NOTICE OF DECISION TO CONSENT TO AMEND A REFERRED PROPOSAL DURING ASSESSMENT

Arrowsmith Hydrogen Project
Assessment No. 2345

Arrowsmith Domestic Hydrogen Project PCD (Final)

Figure 2 Indicative Project Infrastructure Layout

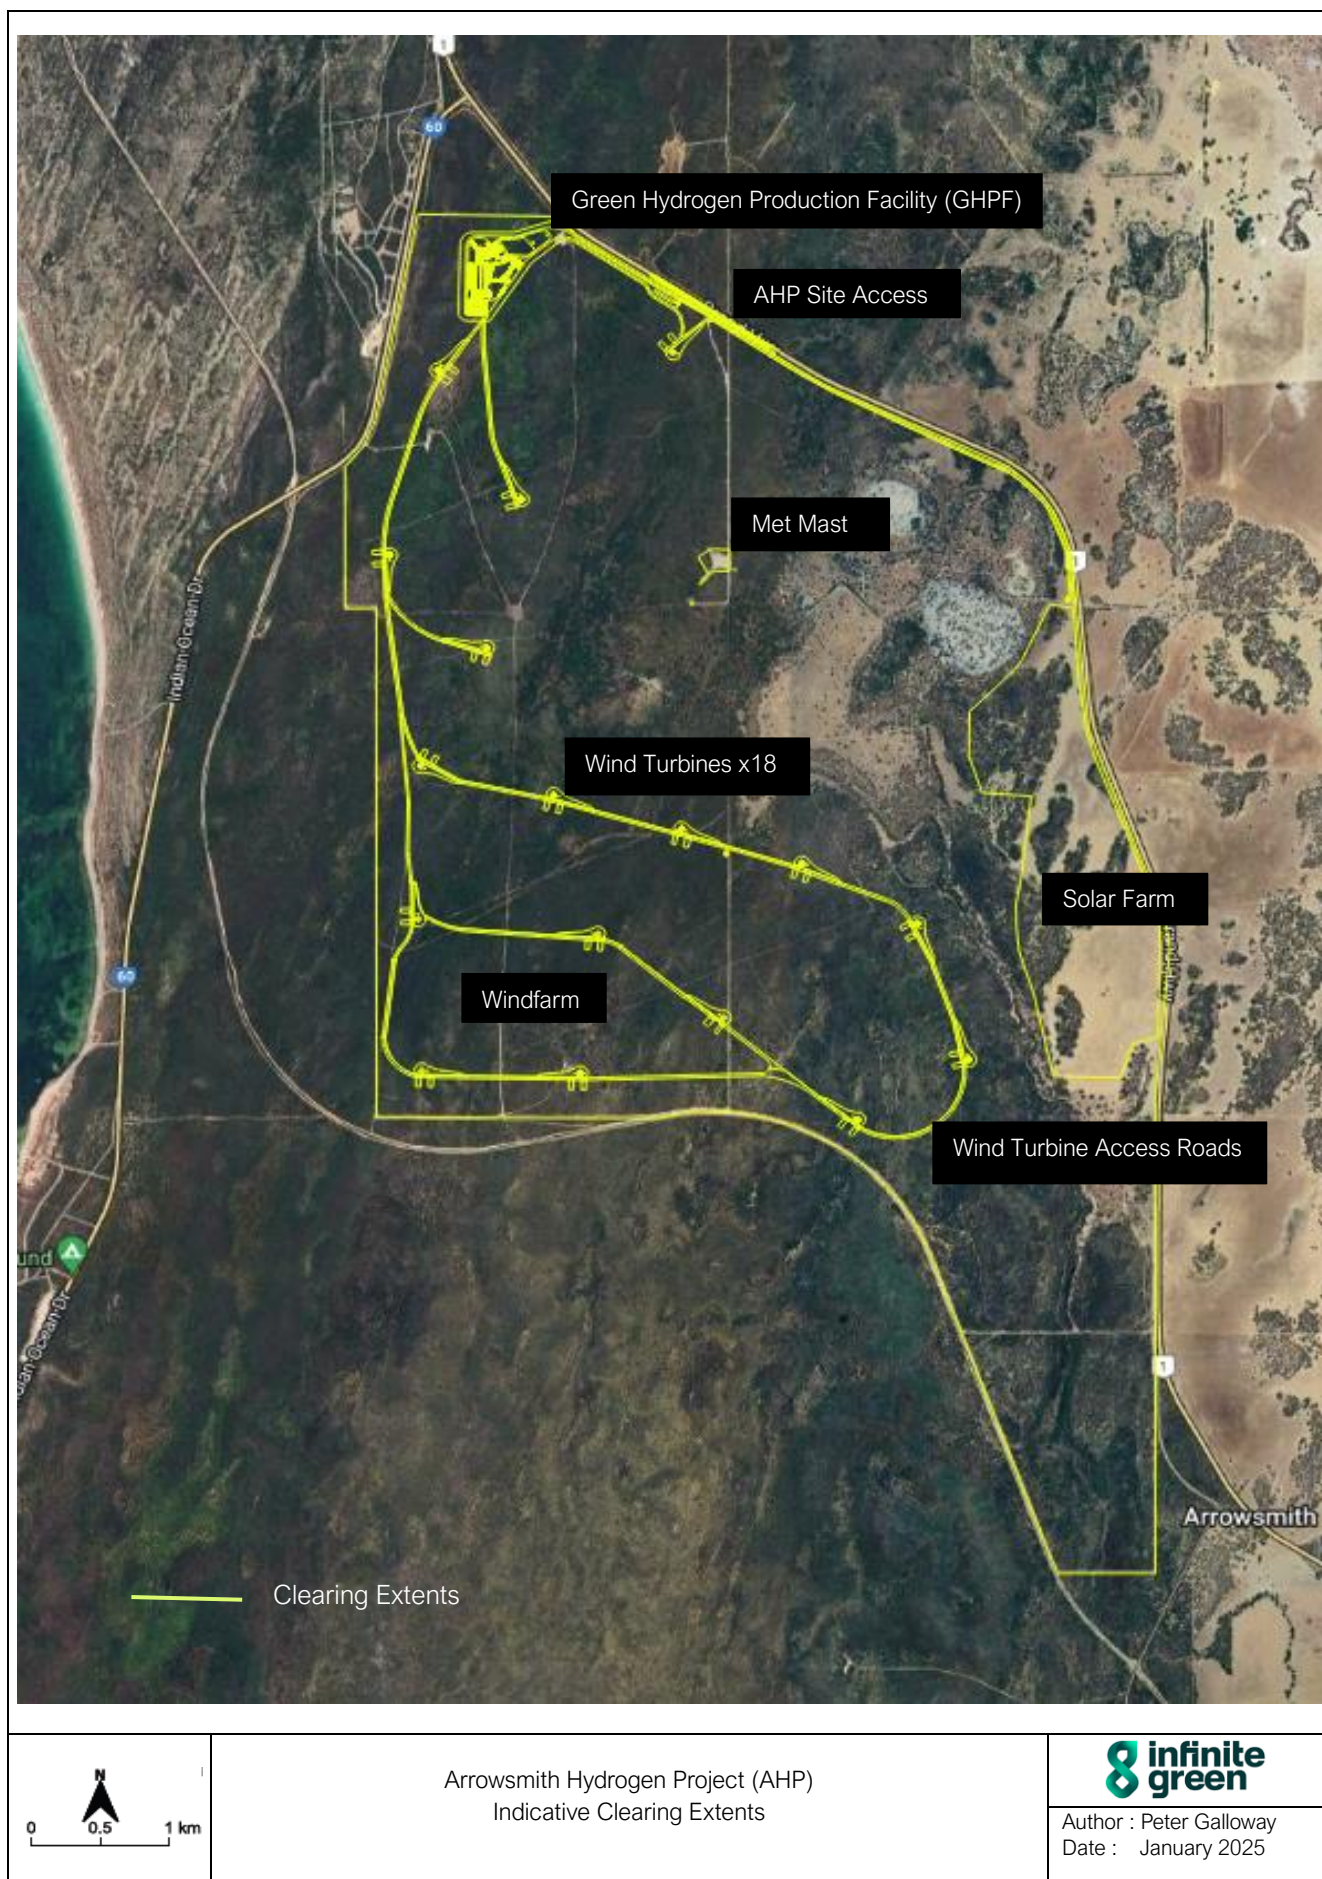
- Rename main plant / trucking loop element to Green Hydrogen Production Facility (GHPF).
- Reduce proposed GHPF footprint by 13.69 ha from 35.88 ha, totalling 22.19 ha.

- Waste management systems
- Office control centre and switch room
- Entry road and gate widening.
- Remove marl pits from the proposal.
- Amalgamate property boundary roads element with Project Fire /Roads element to form “Property Fire Roads Including Boundary (Shire of Irwin/Dfes)”.

- Remove electrical line route extent (overhead power reticulation lines) from proposal.
- Rename Wind Turbines element to Windfarm (Wind Turbines) and reduce proposed extent by 7.14 ha from 22.17 ha, totalling 15.03 ha.

- Predicted GHG emissions have doubled during construction and operation, totalling 14,364t CO₂-e and 632t CO₂-e per annum respectively.
- Change to proposal layout within the development envelope, including transition to an indicative development approach compared to set layout proposed at referral.

Figure 3 Indicative Development Envelope Lot 703

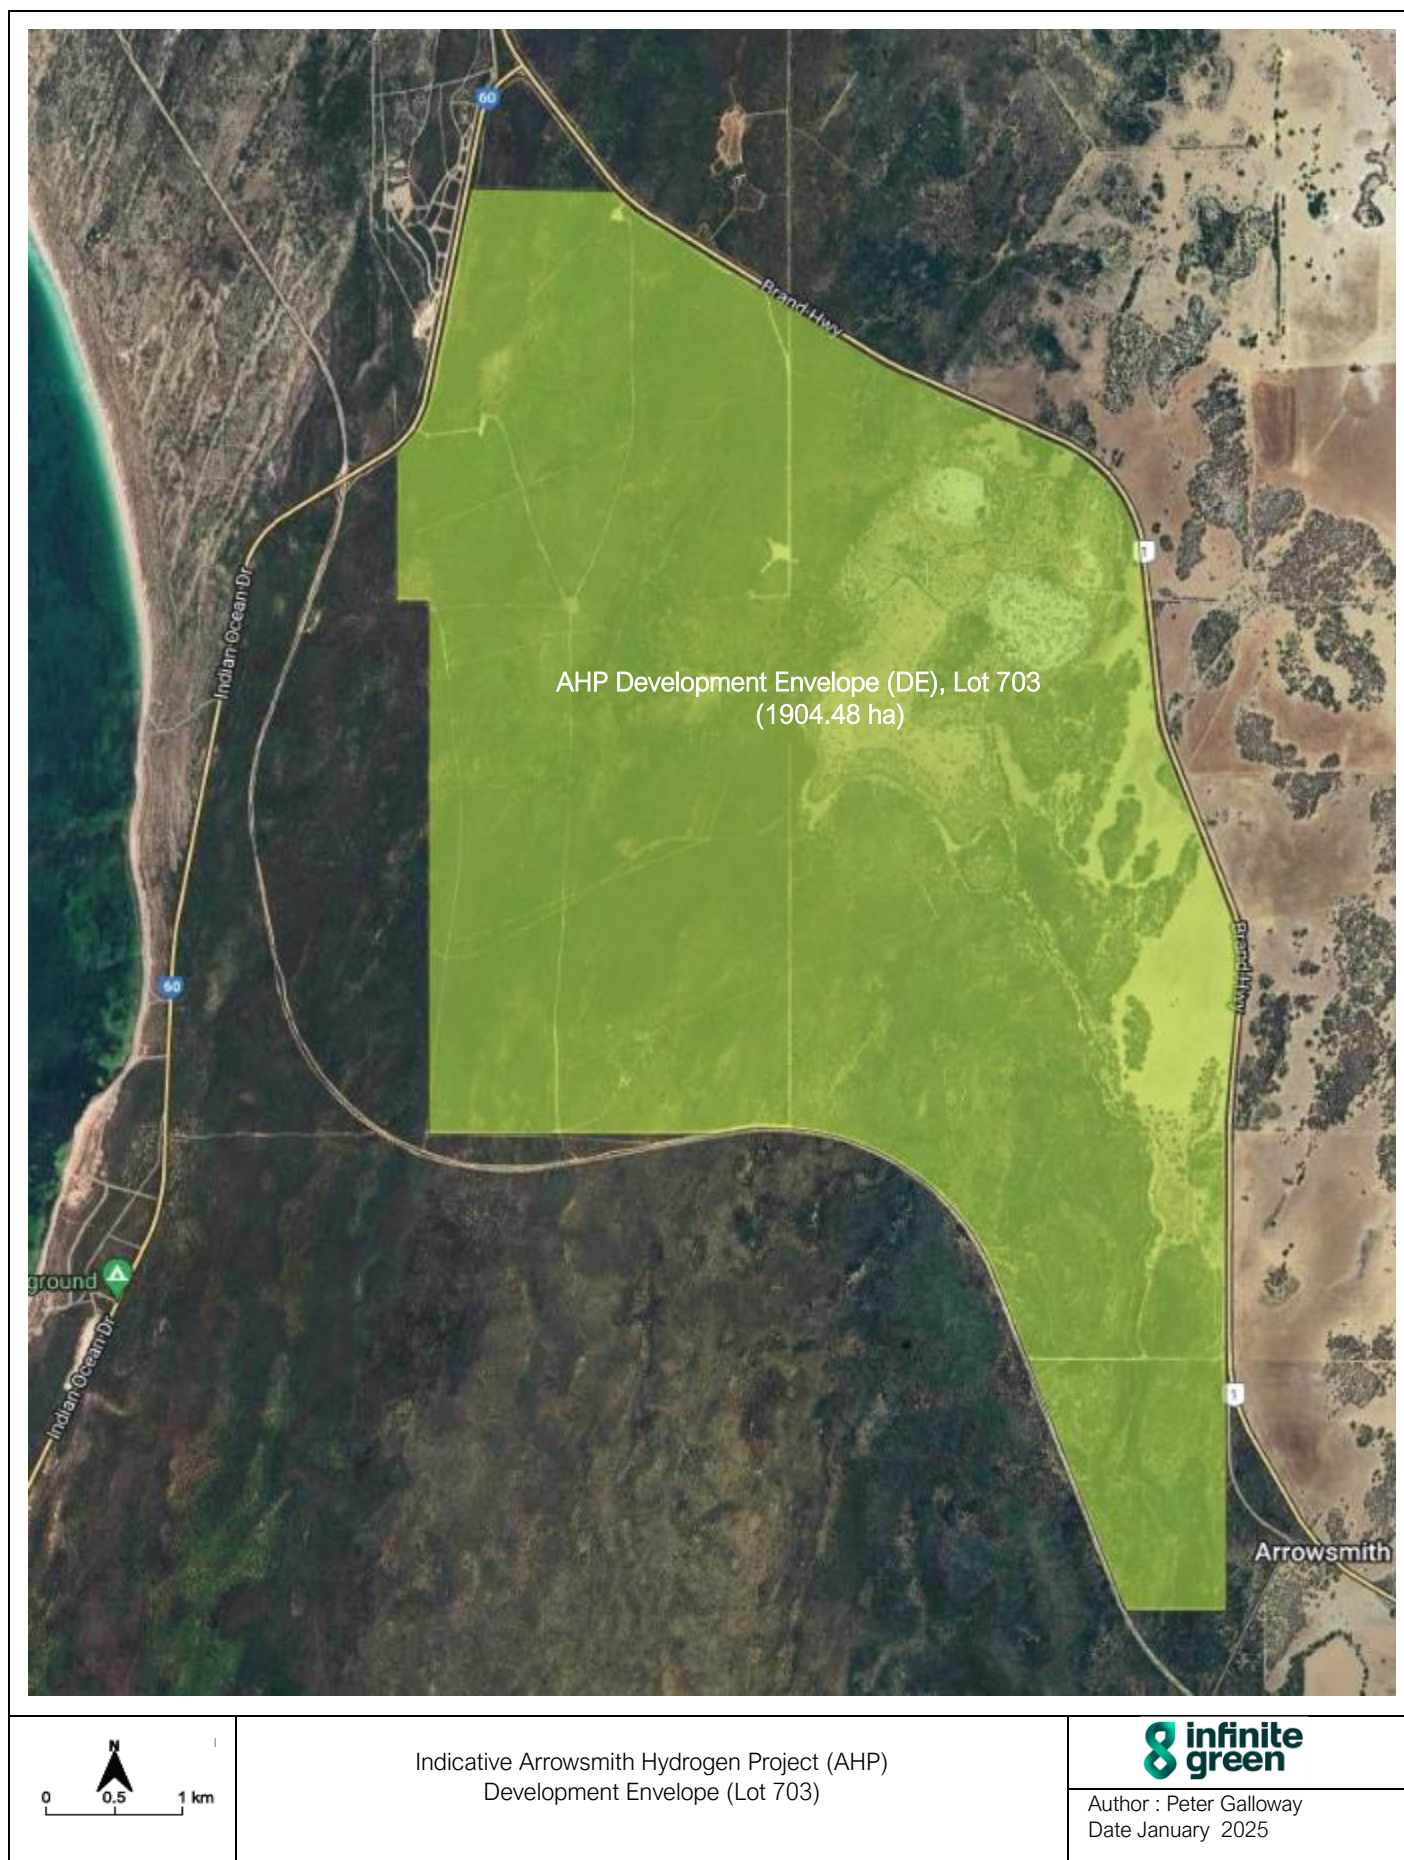
- Updated proposal description and name.
- Addition of grid connection option to the green hydrogen production facility.
- Reduce the total development envelope by 23.52 hectares (ha) from 1929.68 ha, totalling 1906.16 ha.
